**Record of Decision**  
**ITT Sealectro Site**  
**Village of Mamaroneck, Westchester County**  
**Site Number 3-60-027**

# **DECLARATION STATEMENT - RECORD OF DECISION**

**ITT Sealectro  
Proposed Remedial Action Plan  
Village of Mamaroneck, Westchester County  
Site No. 3-60-027**

FIGURE 2

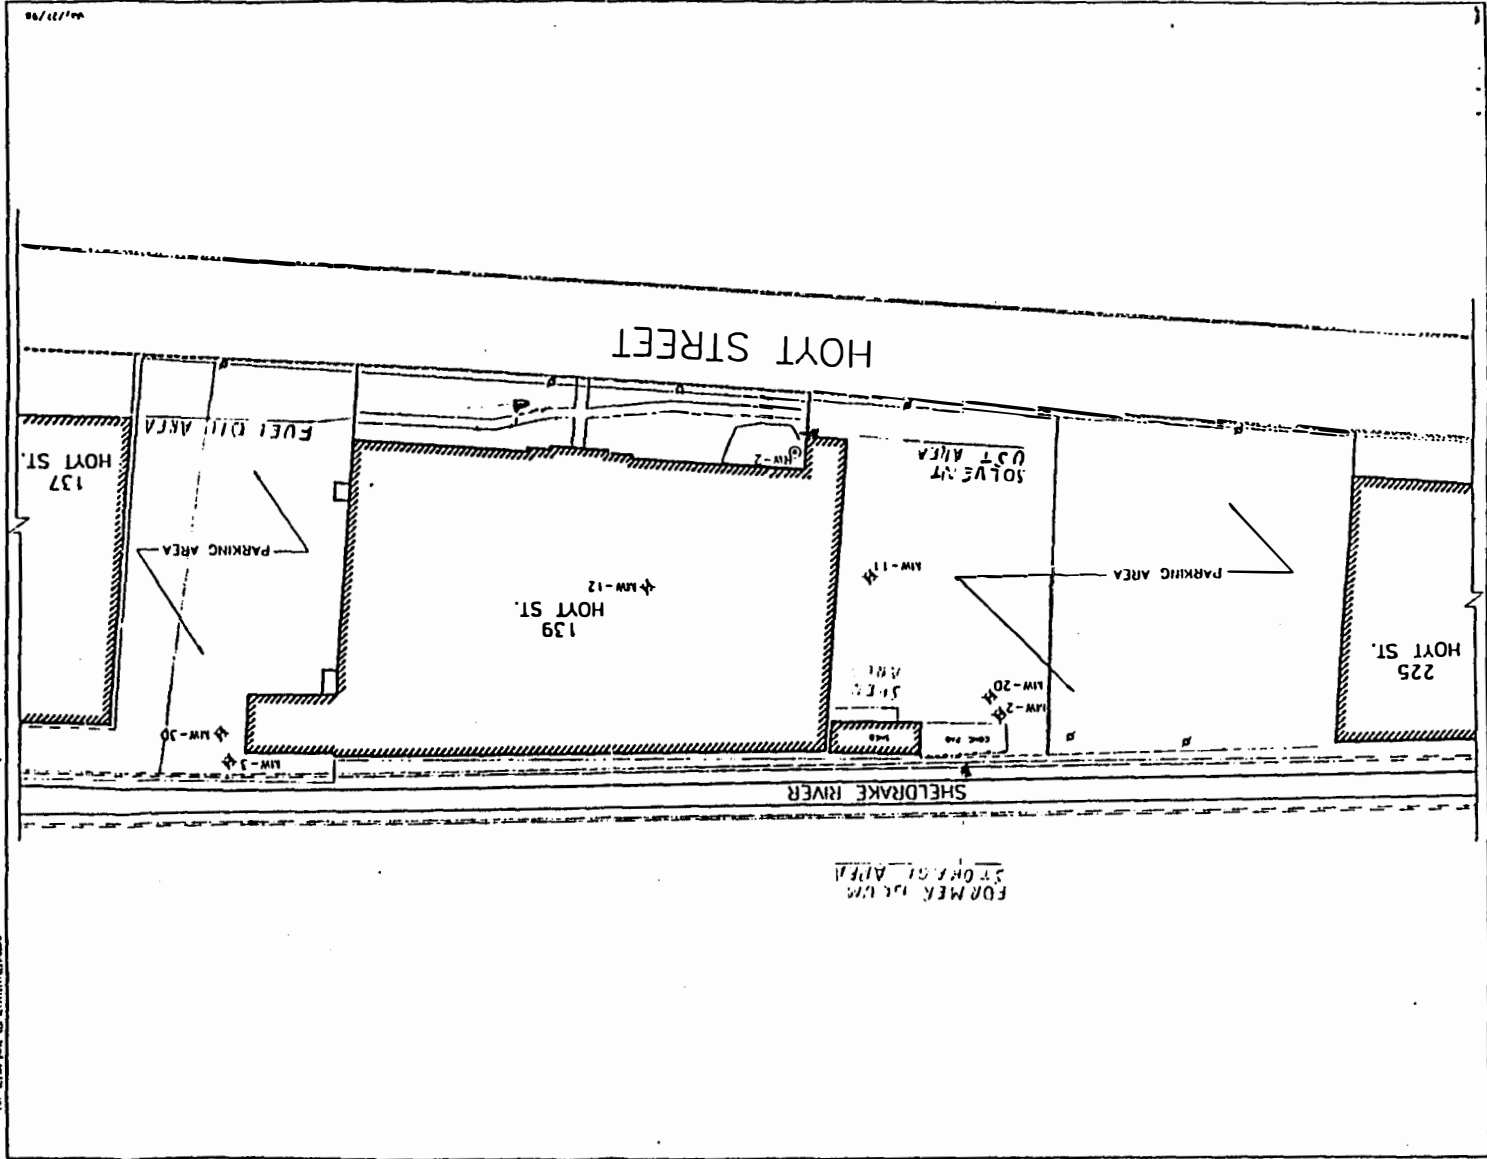
**COMMENT 6:** My business is at 135 Hoyt. How am I affected by this contamination? Is it headed toward my property or is it contained on site? Will I be told if the contamination gets higher toward my property? Will I be advised of the quarterly monitoring results?

**COMMENT 8:** How are the wells selected for sampling?

**RESPONSE 6:** The contamination levels at monitoring wells MW-3 and MW-3D, which are closest to 135 Hoyt St., show low levels of contamination. Further, the contamination in these monitoring wells have been decreasing over time. The groundwater flow and contamination is generally towards the Sheldrake River with minor components of the flow in the downstream and upstream direction that may vary seasonally. Data collected to date

indicate that there is no significant impact by the site-related contamination on 135 Hoyt St. The NYSDEC will be requesting ITT to provide the property owner with regular updates on the sampling data. Alternatively, the property owner may request the information under the Freedom of Information Law (FOIL) from the NYSDEC or NYSDOH. The NYSDEC regrets that the verbal response provided at the public meeting to this comment was in error.

**RESPONSE 8:** The monitoring wells selected for the groundwater monitoring program were based on the level of contamination. Monitoring wells MW-2, MW-2D, MW-3, MW-3D, MW-11, and MW-12 and test well TW-1 which, historically, have had high contaminant concentration are included in the monitoring program. Many of these wells are exhibiting a decreasing concentration trend.
